## **ADDENDUM NO. 2**

### **Request for Proposals #: P-1260-24 Rotary Gardens Power and HVAC Upgrades**

**Appendix A – Crawl Space Photos**

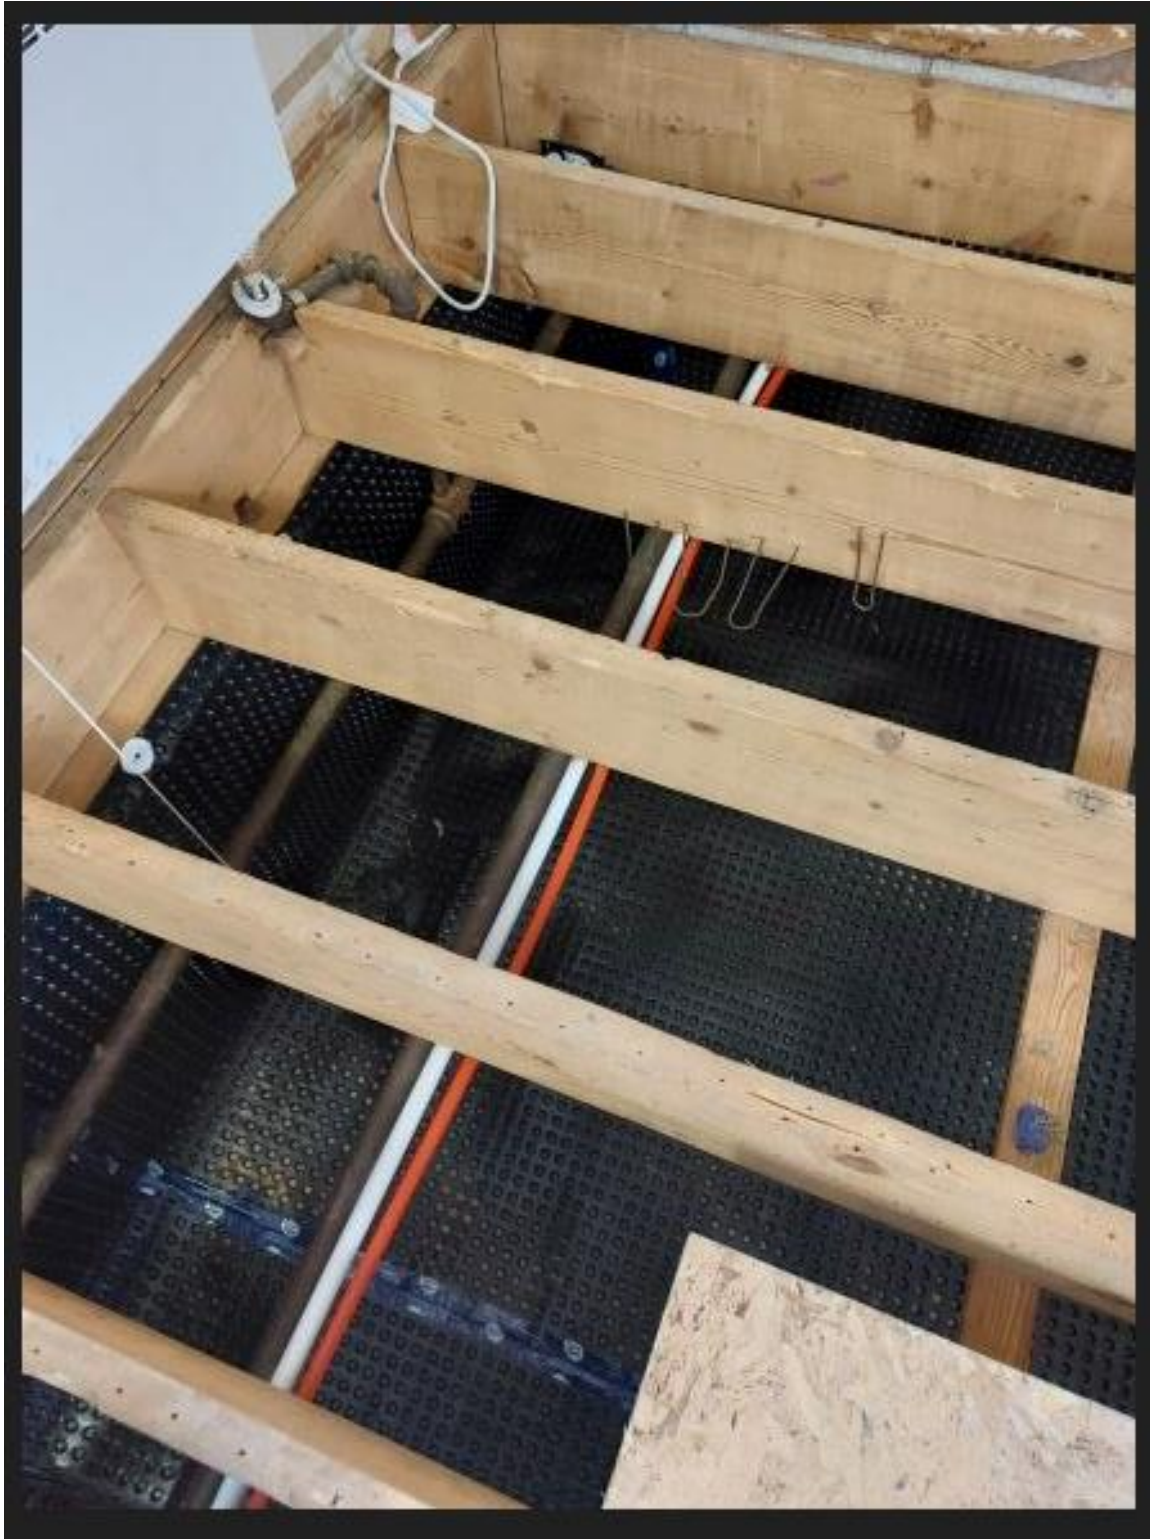
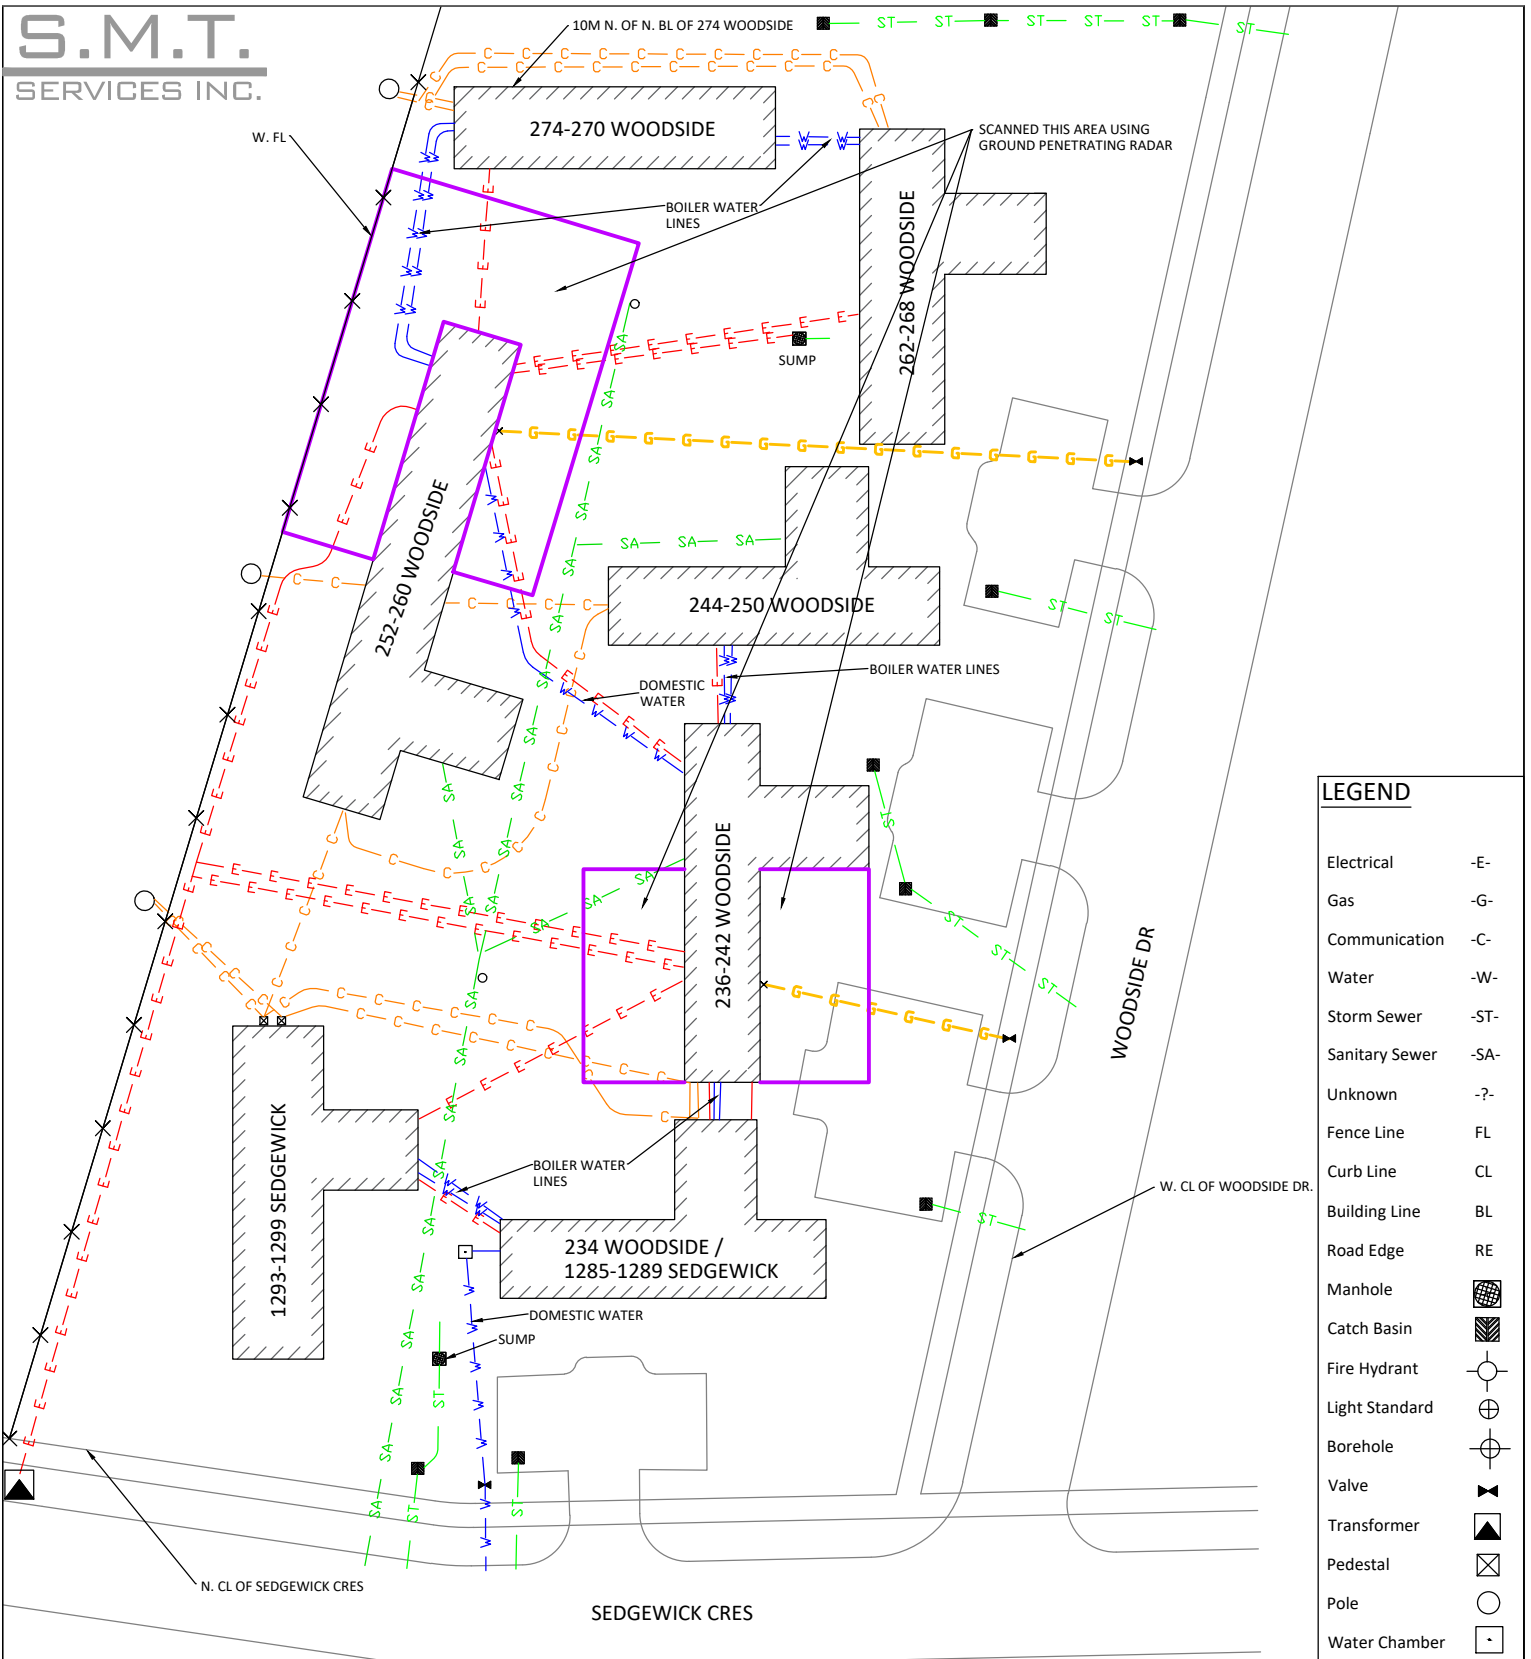
**Question 9:** Do you have any photos of the crawl spaces you can provide?

**Answer 9:** Please see Appendix A – Crawl Space Photos attached hereto.

**Note:** Not all crawl spaces throughout the property have been waterproofed. Some are still exposed dirt/concrete block.
